REZN-23-10

Rezoning Conditions of Approval

- 1. Project Name:** Hartung Fields Lot 8 SIP
- 2. Location:** 2622 BLANEY RD, Fitchburg, WI, 53711
- 3. Permit Request No.:** RZ-2522-23
- 4. Ordinance No.:** 2023-O-18
- 5. Decision Date:** September 19, 2023
- 6. Legal Description:** Metes and bounds
- 7. Current Zoning Districts:** PDD-GIP
- 8. Proposed Zoning Districts:** PDD-SIP

RESPONSE LETTER

SITE PLAN

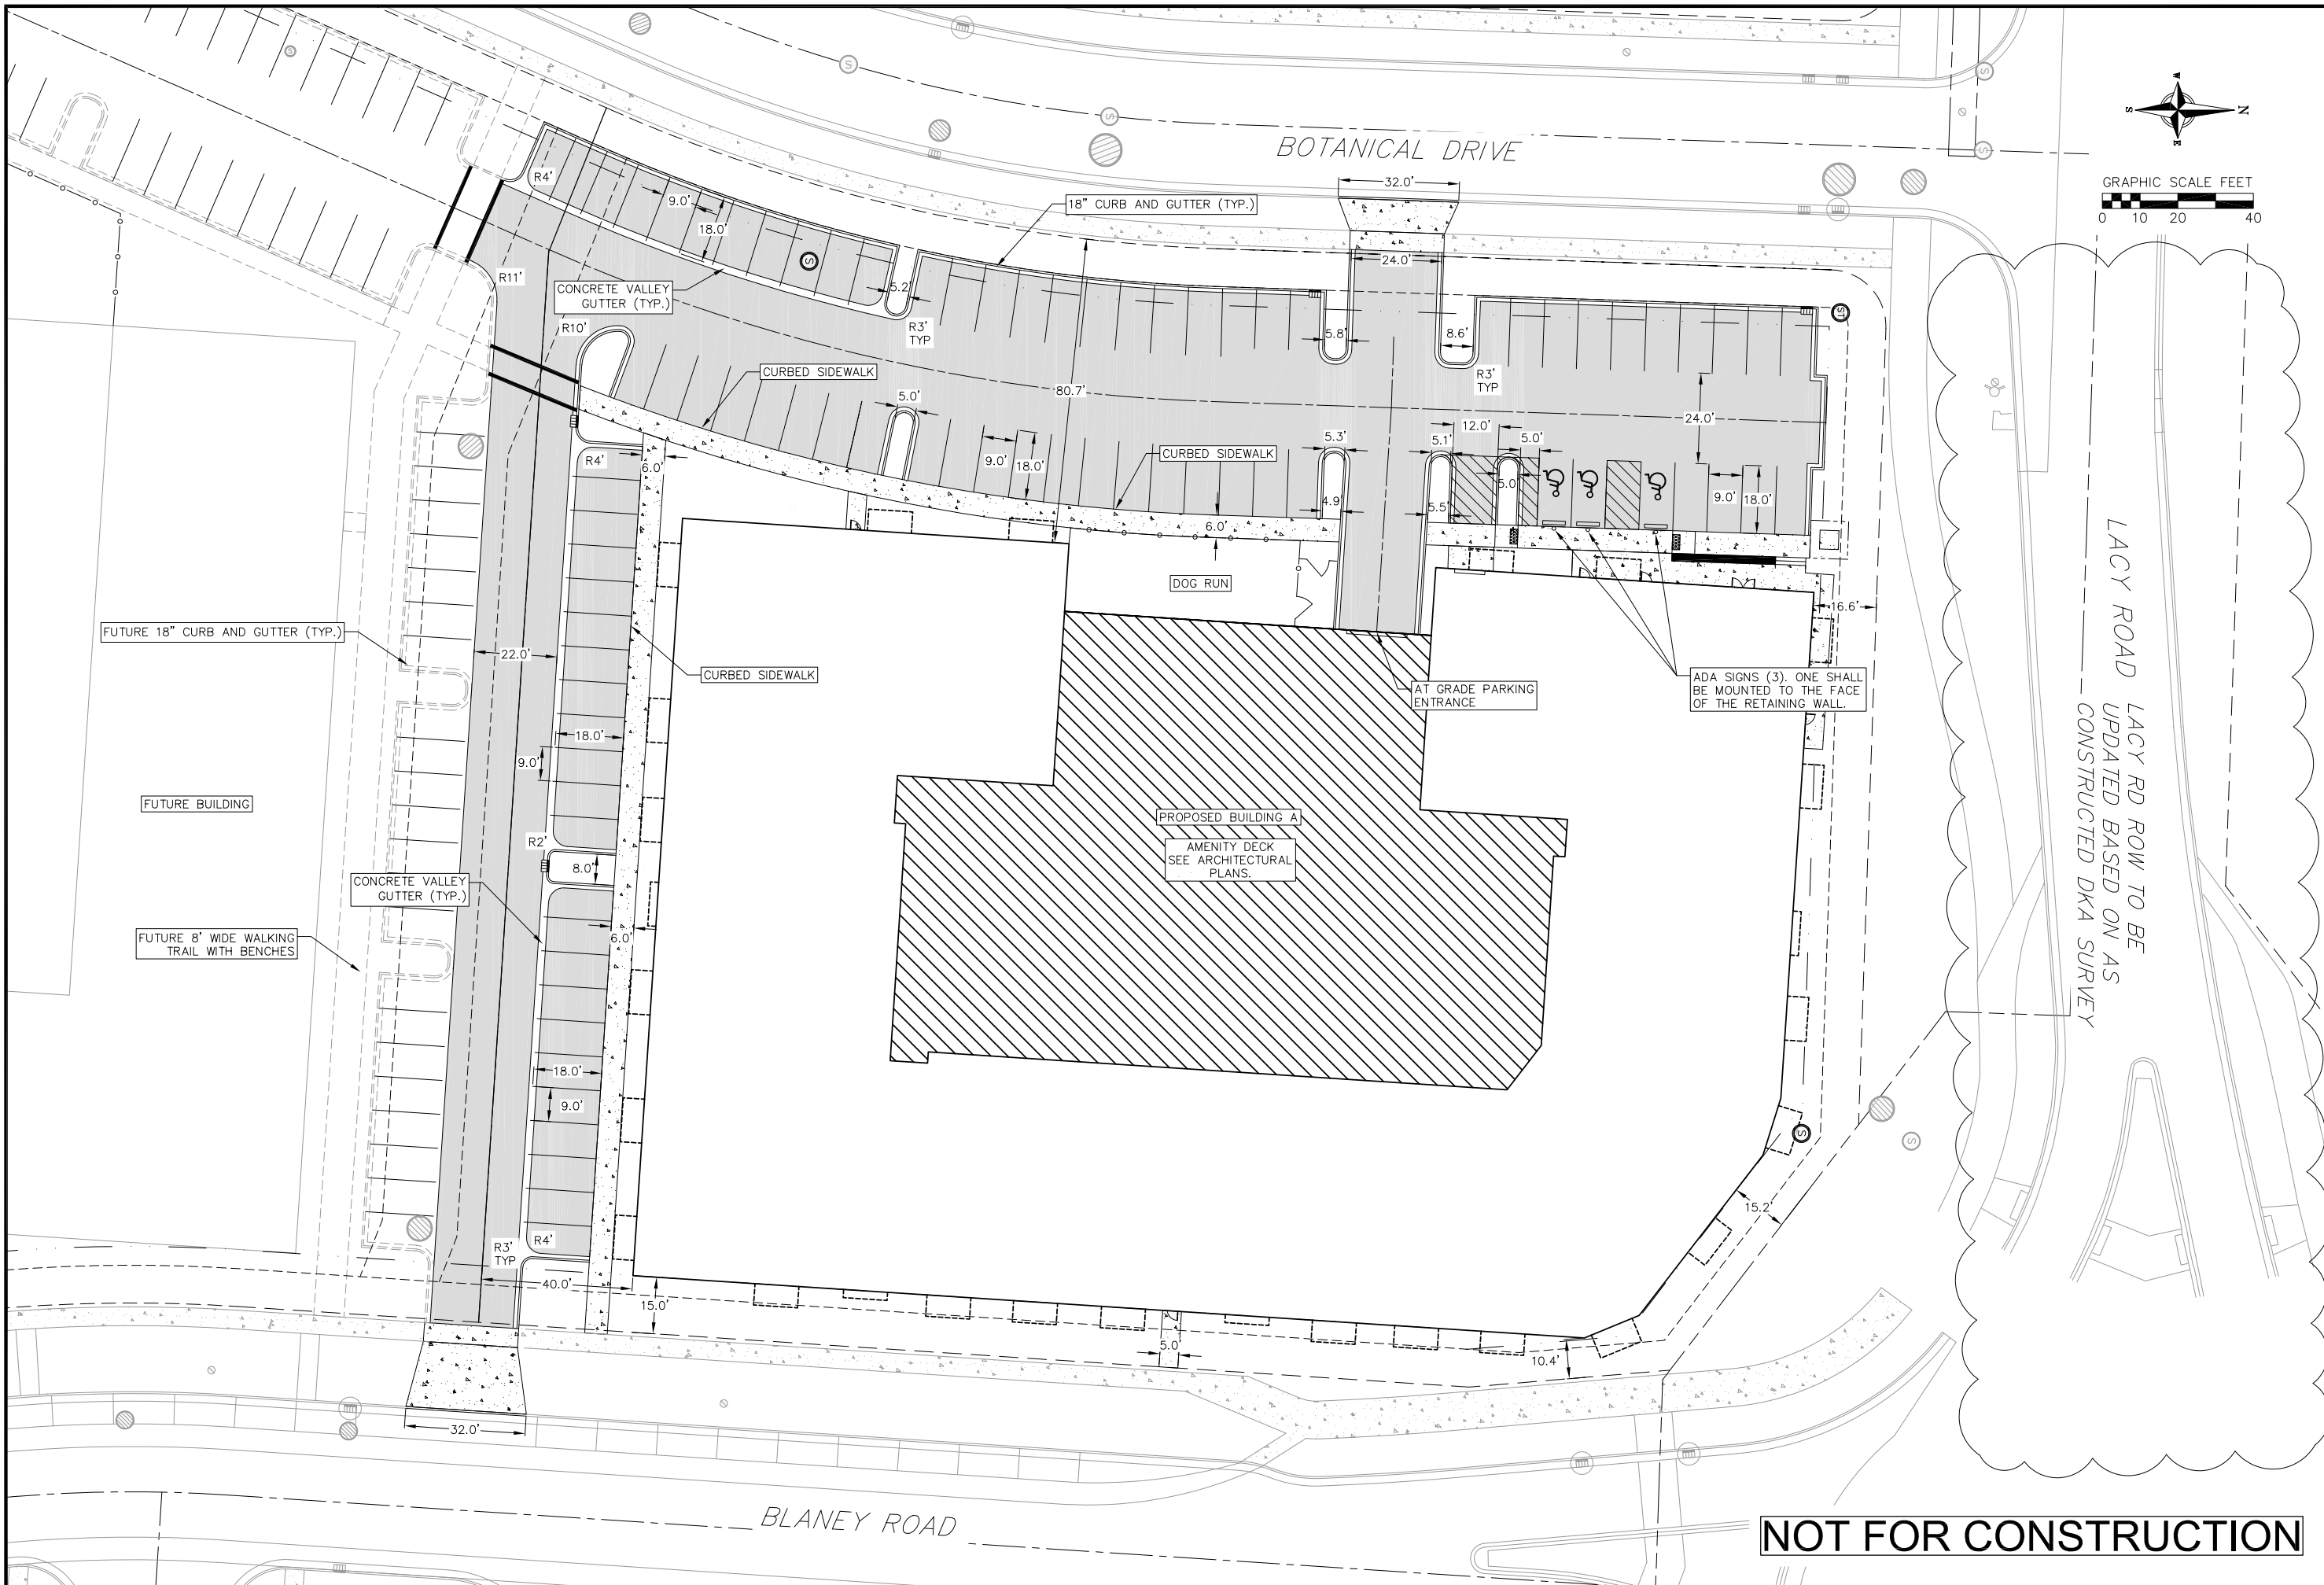
3. Clearly show easements and property lines on the site plan for reference. If the parking areas are shared between lots, a shared parking/access easement is needed.
